Intersection ID: 10024131	Main Street: COULOAK_DR	Cross Street: N/A	Location:	E
ADA ID: 7D5A4BFF52AA	Ramp Type: Perp	Initial Pass/Fail: Fail	Overall Compliance: No	Severity Score: 8.75

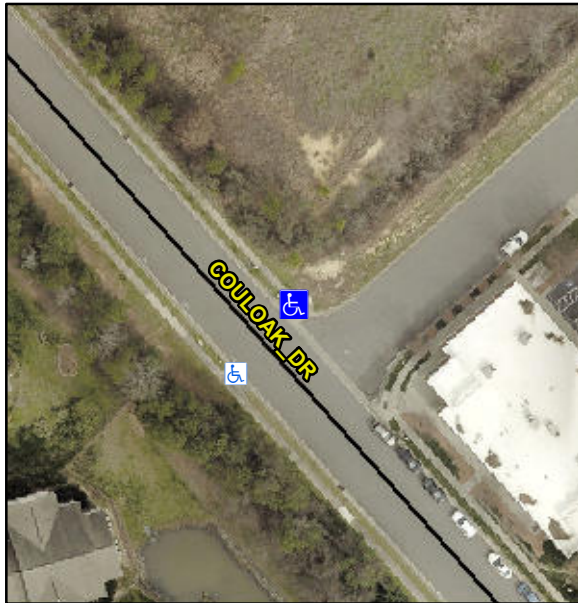
R304.5.1

Compliance	Description	Data	Compliance	Description	Data
N/A	Ramp Length (in)	52.0	Yes	Ramp Slope (%)	5.1
No	Ramp Width (in)	45.0	Yes	Ramp XSlope (%)	0.7
N/A	Flare Type LT	N/A	N/A	Flare Type RT	N/A
N/A	Flare Slope LT (%)	N/A	N/A	Flare Slope RT (%)	N/A
N/A	Flare Traversable LT?	N/A	N/A	Flare Traversable RT?	N/A
N/A	Landing Length (in)	N/A	N/A	DWS Provided?	N/A
N/A	Landing Width (in)	N/A	N/A	DWS Contrast?	N/A
N/A	Landing Slope (%)	N/A	N/A	DWS Length (in)	N/A
N/A	Landing X Slope (%)	N/A	N/A	DWS Full Width?	N/A
N/A	Landing Curb? (Y/N)	N/A	N/A	DWS Offset (in)	N/A
N/A	Shared Landing?	N/A			
N/A	Gutter Ponding?	N/A	N/A	Gutter Slope (%)	N/A
N/A	Gutter Lip Ht (in)	N/A	N/A	Gutter X Slope (%)	N/A
N/A	Painted X Walk1?	No	N/A	Painted X Walk2?	N/A
	X Walk 1 Direction	To SW		X Walk 2 Direction	N/A
N/A	X Walk 1 Width (in)	N/A	N/A	X Walk 2 Width (in)	N/A
	X Walk 1 Slope (%)	3.3		X Walk 2 Slope (%)	N/A
	X Walk 1 X Slope (%)	1.9		X Walk 2 X Slope (%)	N/A

Remove & Replace Entire Ramp.
